ADDENDUM NO. 4

TO: Prospective Bidders
FROM: Brenda Faison, Procurement Agent, Senior
DATE: October 22, 2024
PROJECT: Beatties Ford Road Sunset Pedestrian Improvements Phase 1
 Project No.: 512-16-049

| SHEET NO | DRAWING TITLE |
|----------|----------------------------|
| 25 | SIGNAL PLANS – SIG1 – SIG6 |

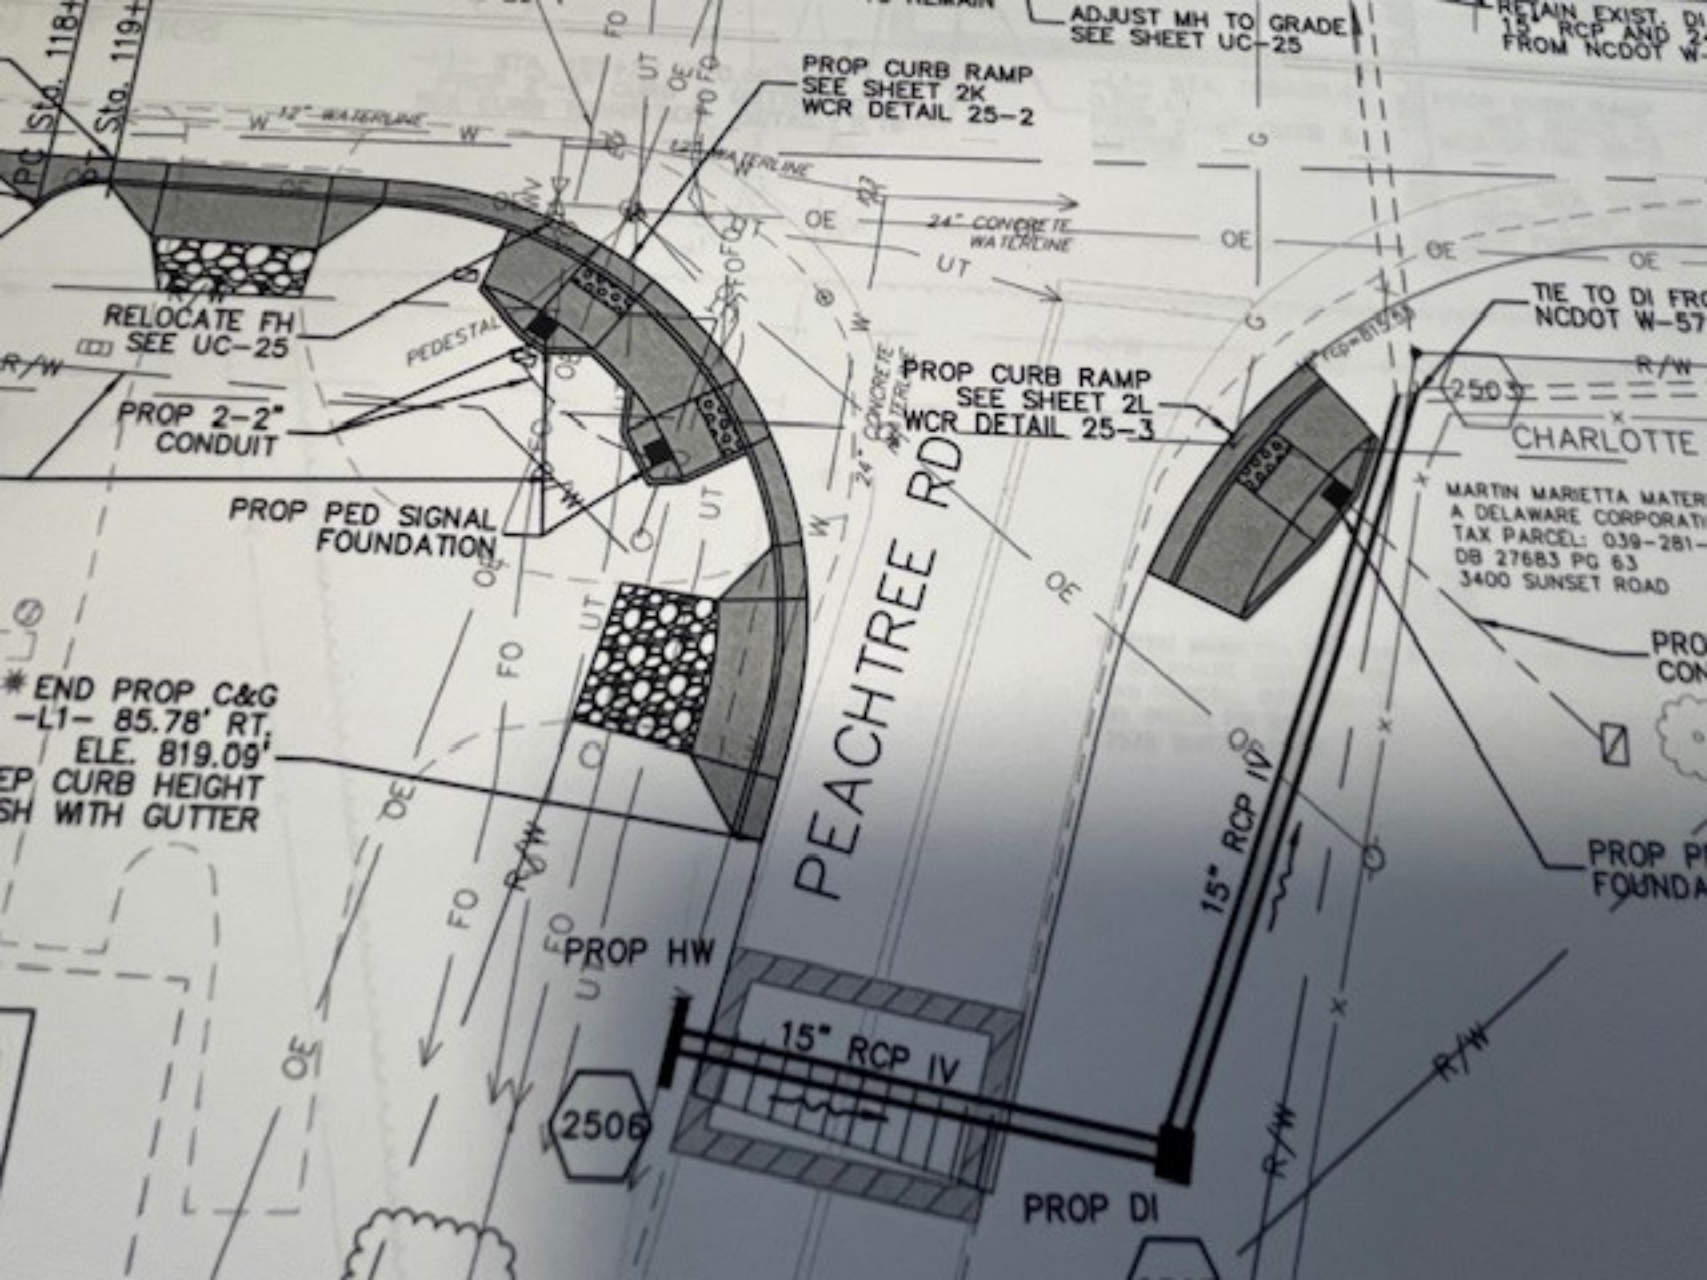
- 1) Regarding the DRAWINGS, See screenshot(s) of Plan Sheet 25 where the pole will be located.

1. Line items 135 and 136 are for a 15 ft pole and base but not on the plans(see attached). Please advise.

2. These items are not on the signal plans. The pedestrian signals will be mounted on the 10 ft poles according to the plans. Usually the 15 ft poles are used for cameras. Please revise plans or remove the 15th ft pole line item.

Answer: *The information is not included on the plans but in the manual. Article 3: CDOT Implementation Special Provisions See SP-21 Pedestrian Poles and Bases.*

Those line items pertain to the Pedestrian Signals the Contractor will have to install at Peach Tree and Sunset Road. They are outlined in the project manual and there should be a plan incorporated in the plans from CDOT Implementation. They will be titled SIG1-SIG5 following the erosions control plan sheets.

Answer: *There will be two different sizes of pedestrian pedestals installed with this project. There will be one 15 ft tall pole and two 10 ft tall poles. Please see attached screenshots to include a google map of the area as well as the Plan sheet 25 indicating where the pole will be located.*
